CSB-1224-2
Country : UK
Date : 2/18/2007
APC : ALL
Repair Level : 2

RAZR V3i - GSM - Static Audio – P-Flex shorted to display bezel
V3i & V3t

Placement of the Kapton Tape

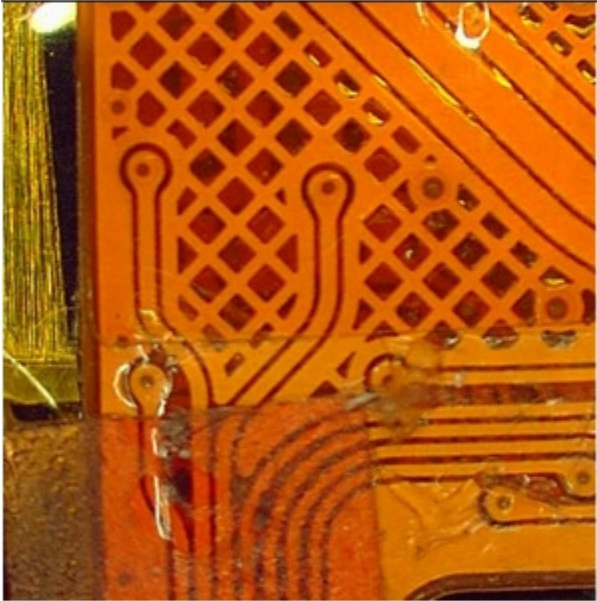
There are two main contributing factors, the placement of the kapton tape and the burr on the display bezel. First the kapton intended to protect the P-Flex from the display bezel edge which has burr was not being placed correctly during the assembly thus allowing the bezel burr to come into contact with the flex. Second the burr created during the stamping of the display bezel was found to be sharper than expected, which allows the burr to become more dangerous to the P-Flex.

Incorrect -
Placement of tape
on the P-Flex

Manufacturing has corrected the placement process of the kapton tape on 2/9/2007. The display supplier is improving the manufacturing process to reduce burrs of the bezel.

Correct of the b

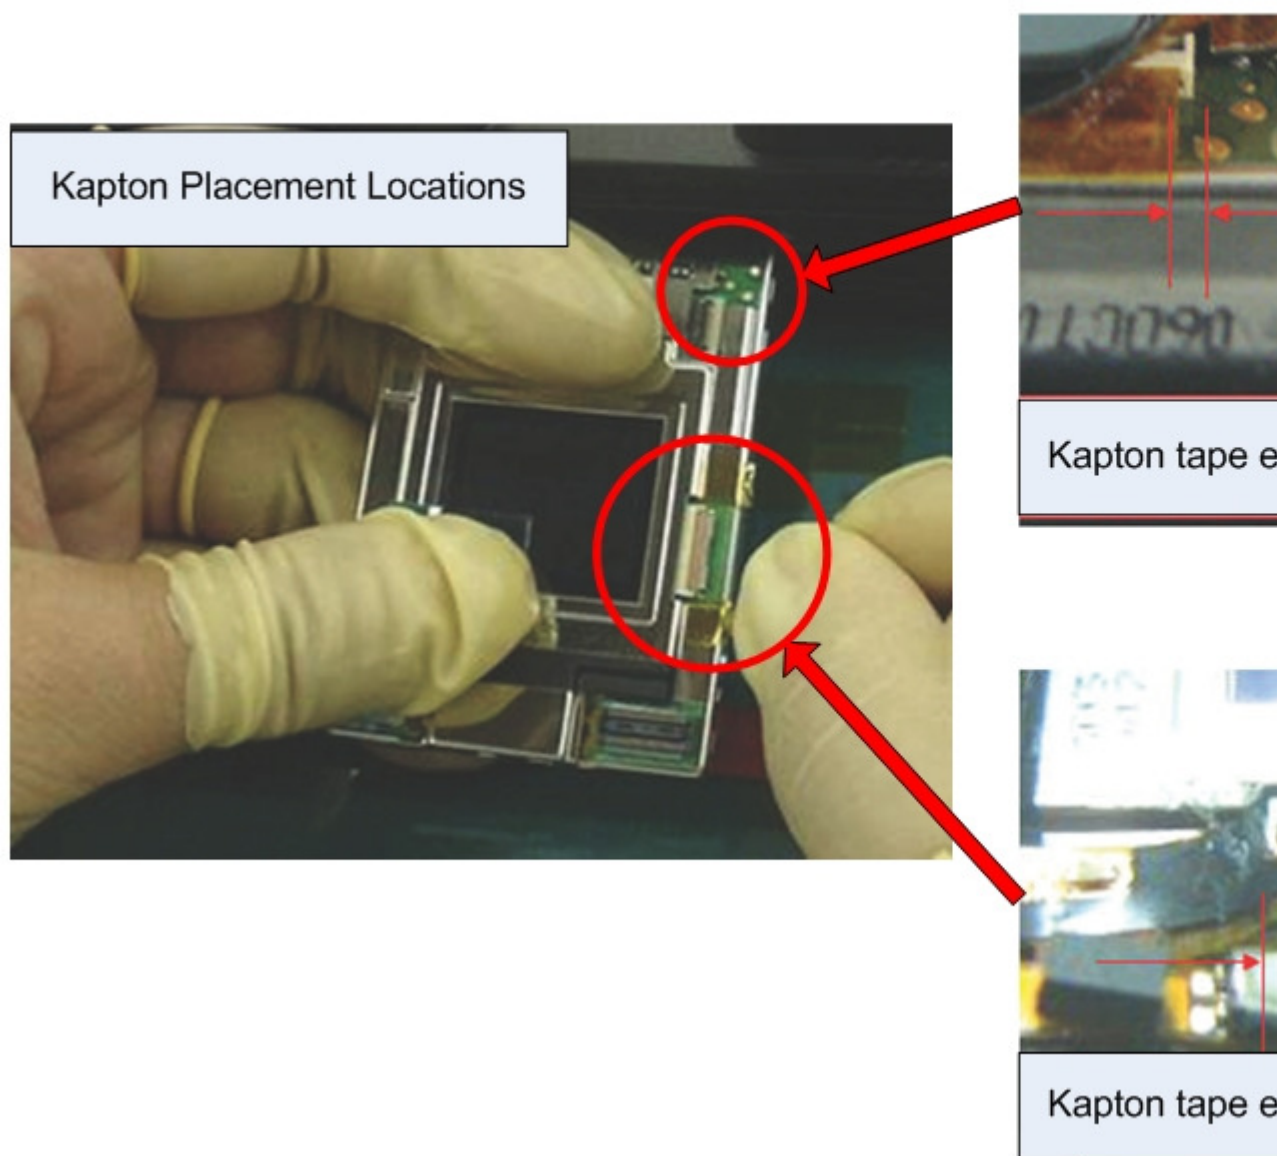
APPLY KAPTON TAPE TO THESE 3 EDGES OF THE DISPLAY BEZEL.

When servicing any V3i/V3t customer phones with described issue, the P-Flex must be replaced and kapton tape added. Pe Flex Assy # 8489906Y01 Kapton Tape # 1171760D01. All repairs in where the P-Flex is replaced, the kapton tape must be placed on the display bezel with the bend corner and burrs completely covered (See Placement Instructions).
